Whites Point Quarry and Marine Terminal

RESPONSES

VOLUME III

Figure 2.2-R1

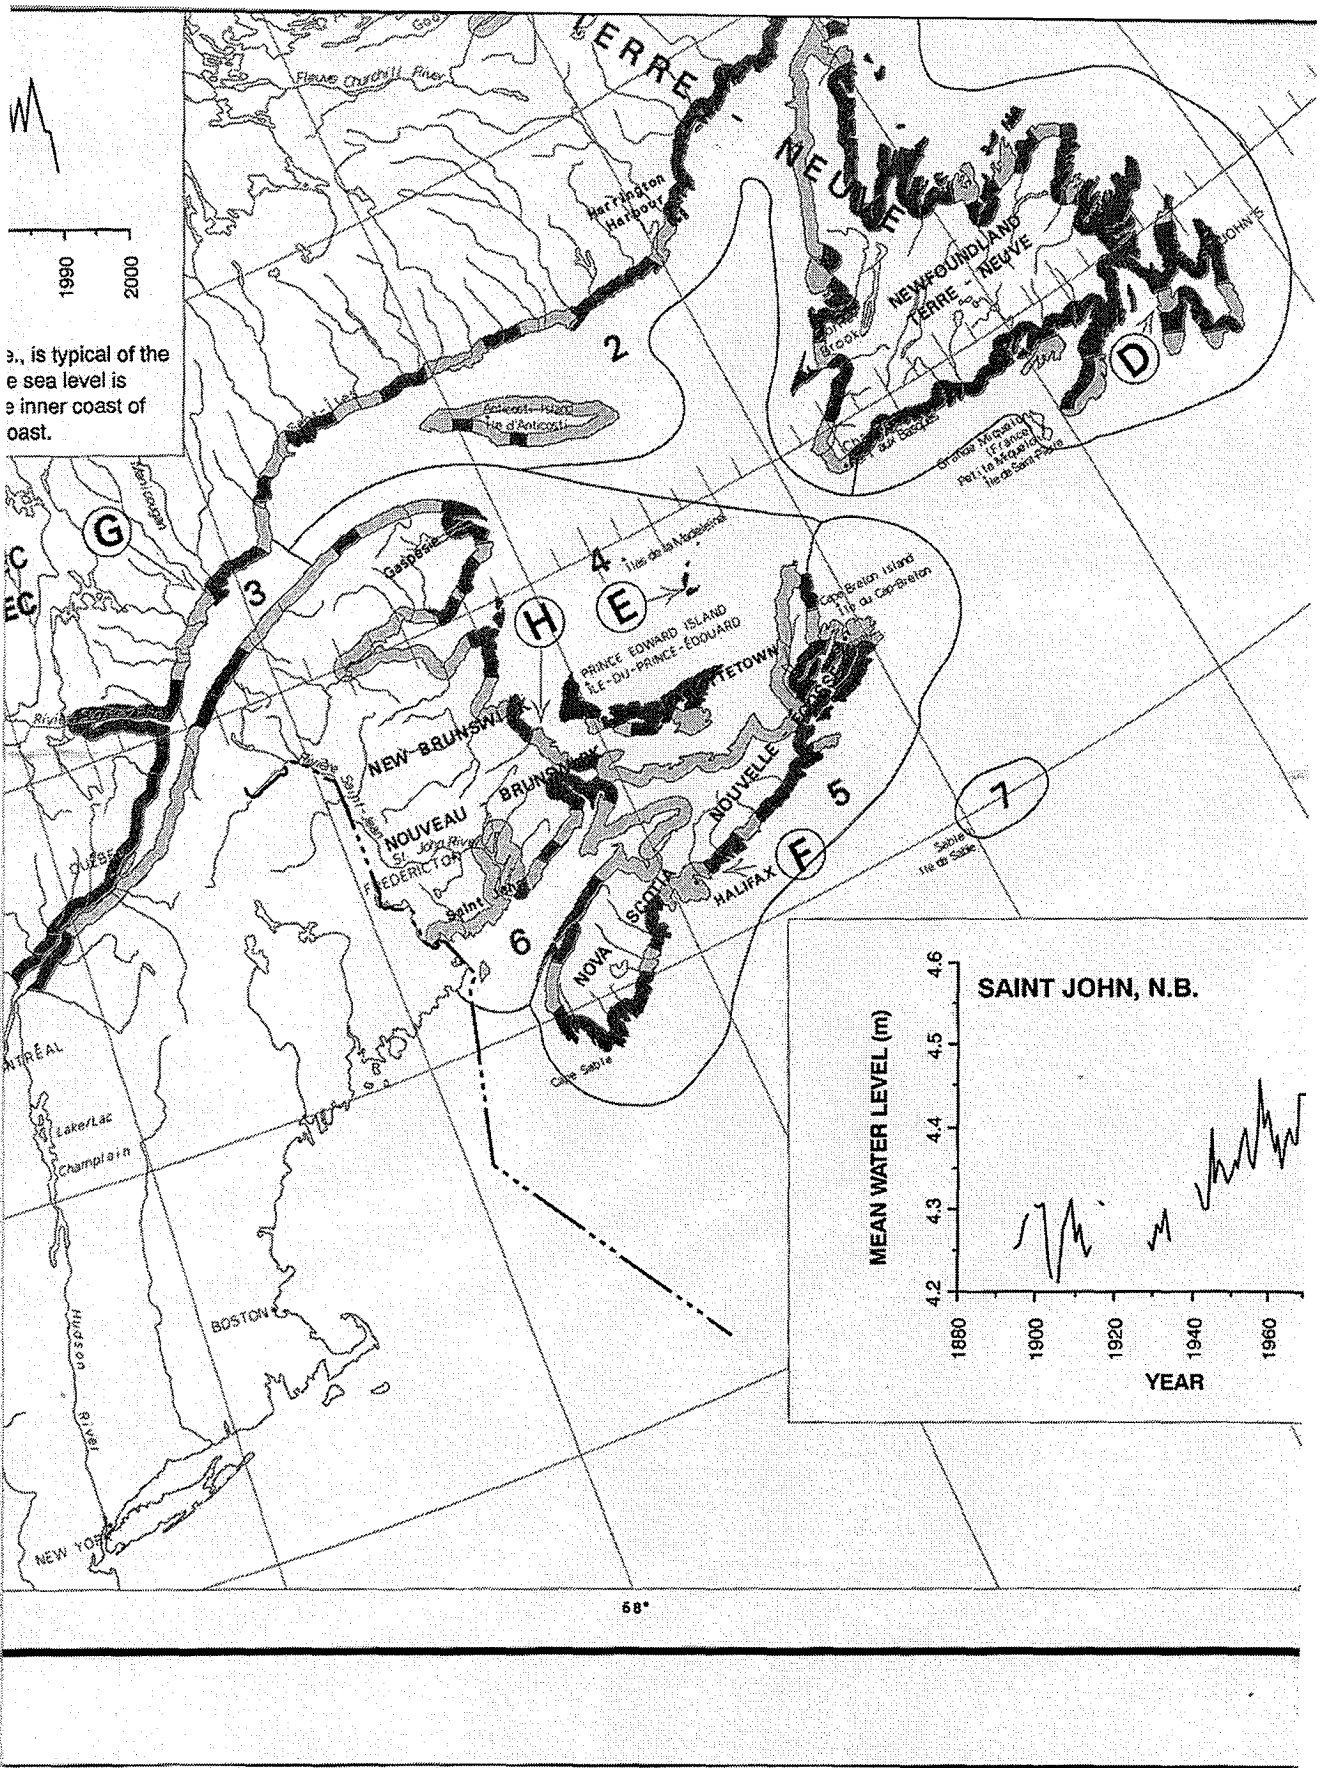
The deepest water closest to land in the Bay of Fundy that provides an unobstructed, direct, safe and deep water route to the adjacent Gulf of Maine occurs along Digby Neck and specifically at the Whites Cove area (Figure 4, EIS Reference Volume III, Tab 15). This section of Canadian Hydrographic Service Chart #4011 shows this relationship through the

The berthing dolphins will be located off Whites Point along the 16 m water depth contour as indicated in Figure 2, Vol. III, Pg 46, of the EIS. Samples collected from the seabed of the broad regional area, Vol. II, Tab 9, Figure 2.2 of the EIS and Map 7, Vol. V, Tab 26 indicate that with the exception of sample no 21, Figure 2.2, that was collected in 29 m water depth, all other attempted sample locations in depths shallower than 30 m could not retrieve sediments. This ground truth evidence supports the sidescan sonar high backscatter and rough and undulating surface signatures for an interpretation of exposed bedrock over the region extending from the shoreline to depths of 30 m.

Figure 2.2 Volume II, Reference Document 9 has been revised to show the proposed location of the marine terminal in relation to the nearshore sediment sample locations. This revised figure follows as **Figure 2.2 - R1**.

Figure 2.2 R1 has been prepared for clarification on this matter to assist the reviewer and shows all of the physical elements to address the location of the marine terminal relative to bathymetry, seabed samples and seabed geology. This map shows that there is no sediment at the seabed beneath or near any of the proposed foundations for the offshore structures. The nearest thin sand patch that overlies bedrock is over 125 m to the northwest of the marine terminal.

Tab 14 - Figure 1-R1

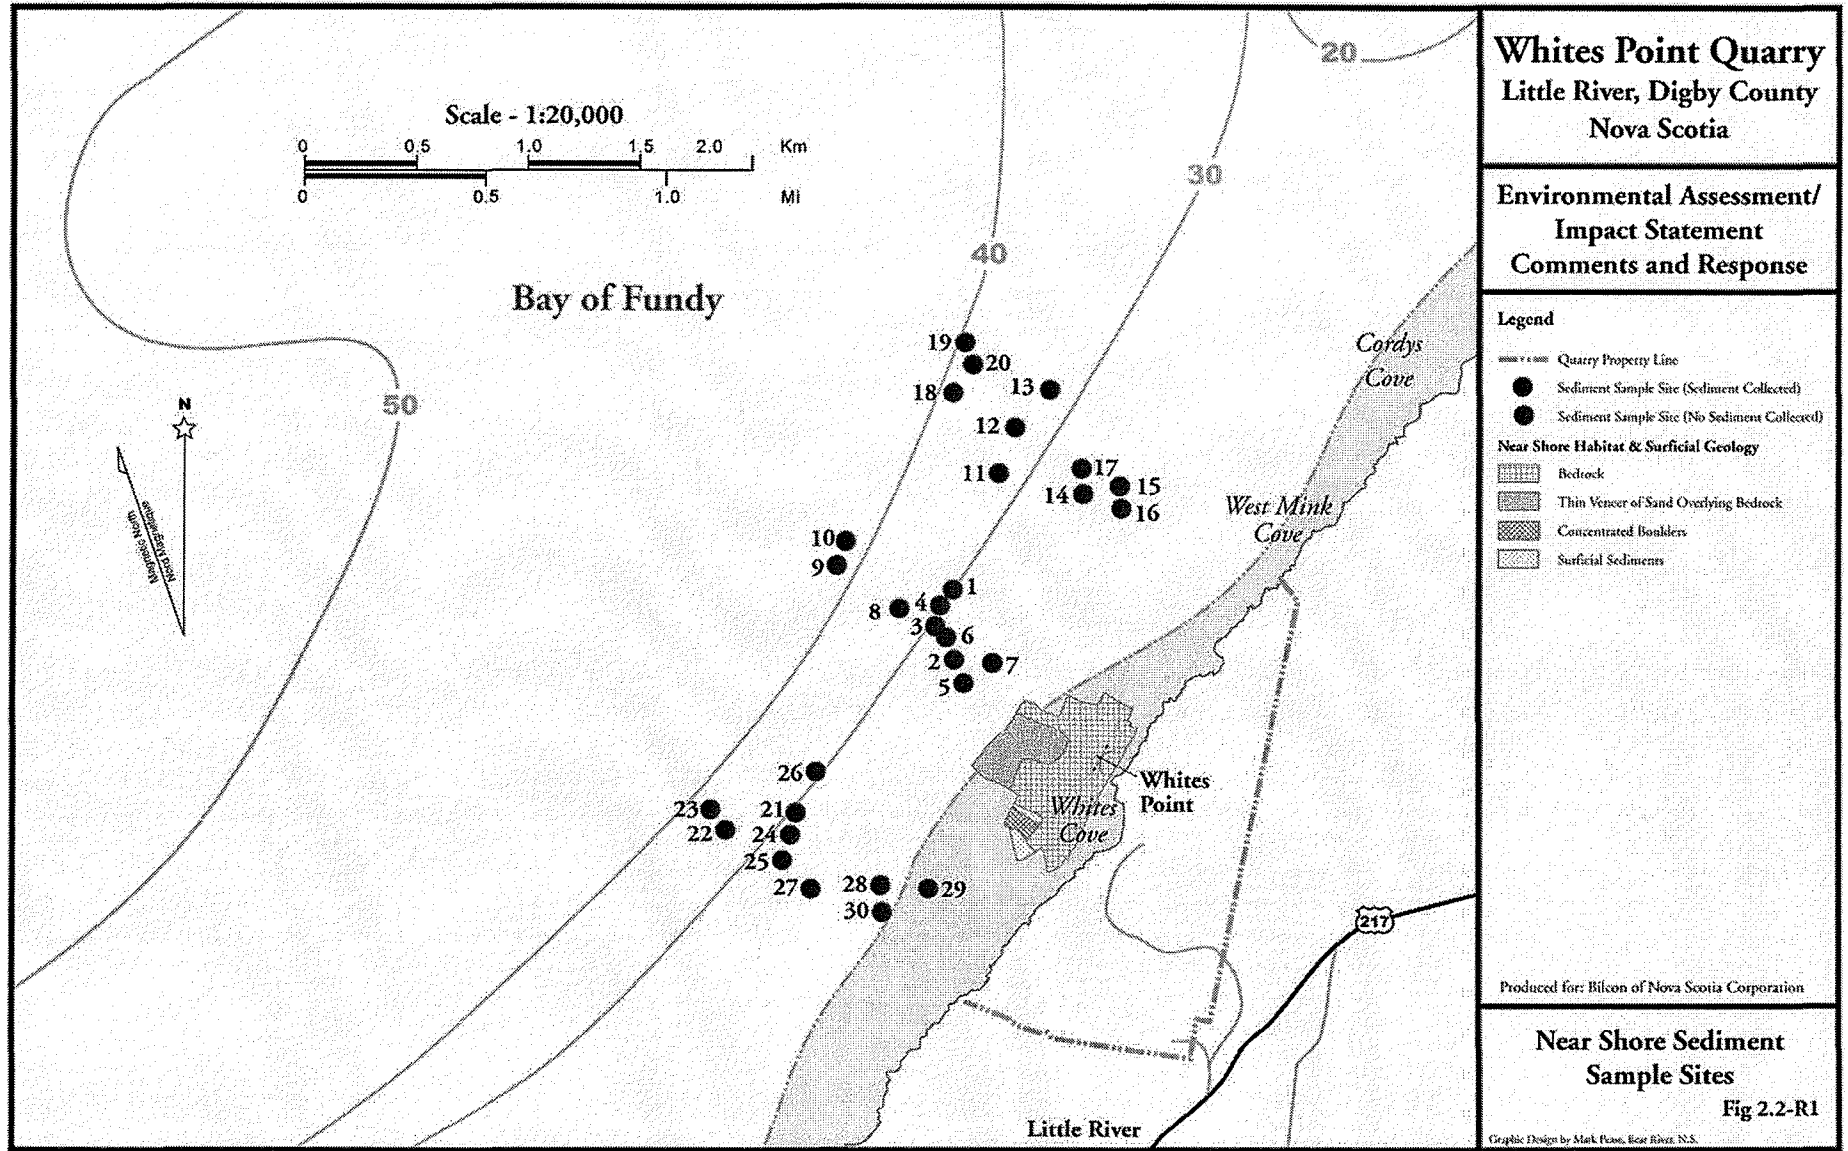
1. *Vol. III – 14 page 10.*
 - *Correct "nautical km" to "km"*
 - *Distance scales are missing on Figures 1 to 4*

Tab 16 - Figure 1-R1

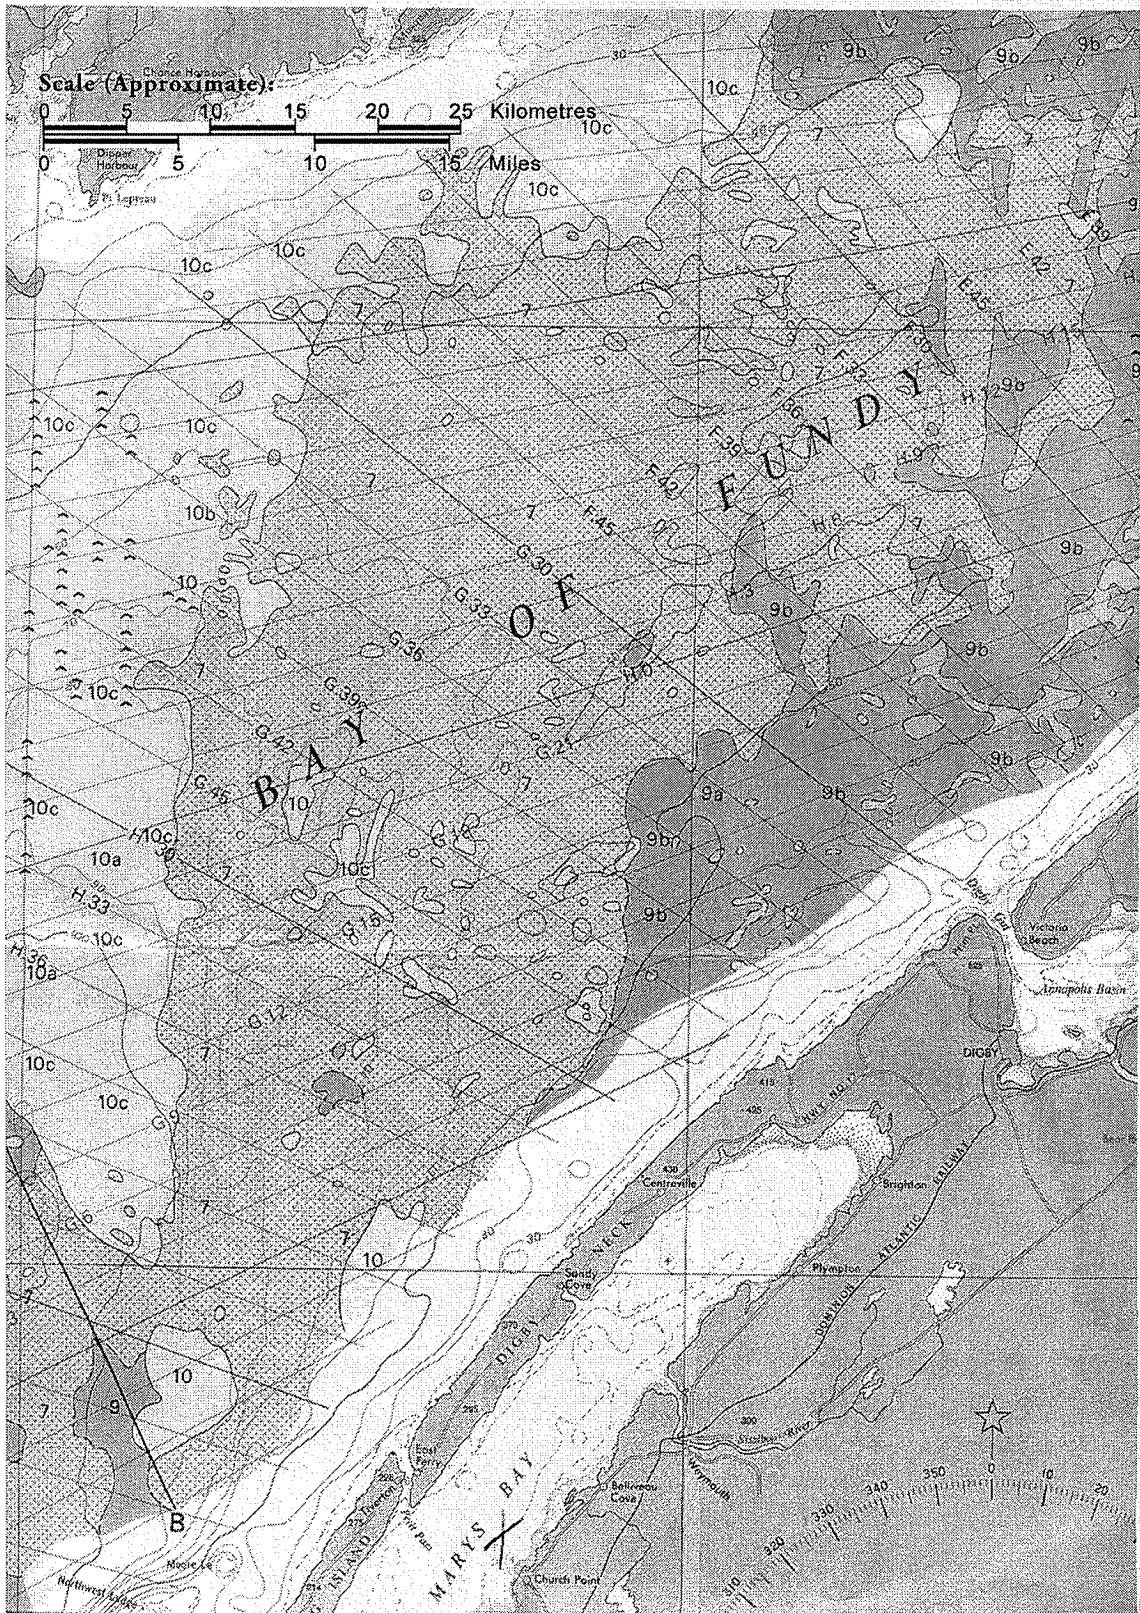
- *No distance scales on Figures 1 to 4, 6 to 8.*
- *Figure 4 particularly lacking in distance scales in two directions.*
- *Reference to Figure 3 is out of sequence in the text.*

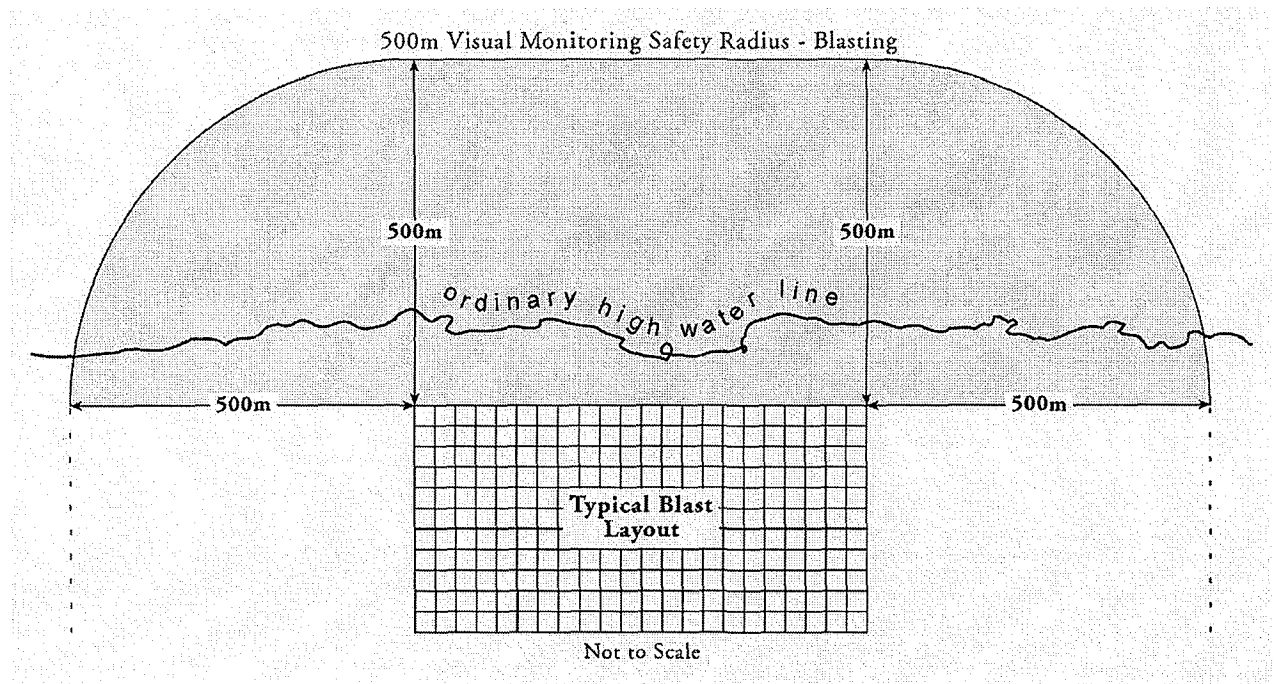
Page 124 – If the monitoring zones are calculated from the blast location, the proponent should explain how the marine mammal monitoring zones are determined given that the blast will not be a single point but a series of blasts.

The proposed visual monitoring zones are calculated from the on-land blast location. The following diagram is presented as an example to illustrate a typical calculation for determining a 500m monitoring zone.
